# Service Bulletin

Bulletin No. 2009-68  
CMD 2009-08

## Activation of the Low Drive Lube Alarm for QSD 2.8L & 4.2L Models Models Affected

All Cummins MerCruiser Diesel QSD 2.8L and 4.2L sterndrive models with SmartCraft 2.2 (48-Pin System Integration Module).

#### SIM Calibration Number

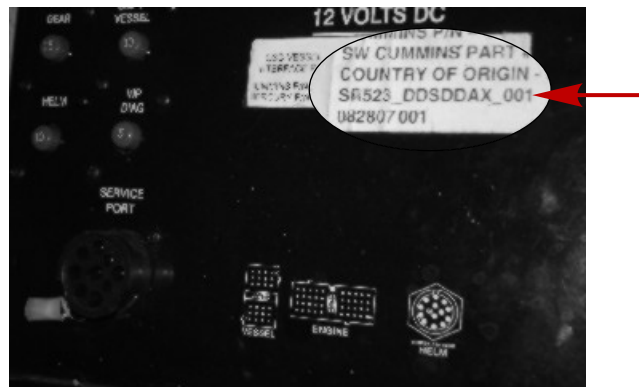
Confirm that the SIM has the affected calibration. The SIM calibration number is provided on the SIM identification decal.

**IMPORTANT:** After updating the SIM, cross out the old calibration number on the SIM identification decal and write the new calibration number with a fine-point permanent marker.
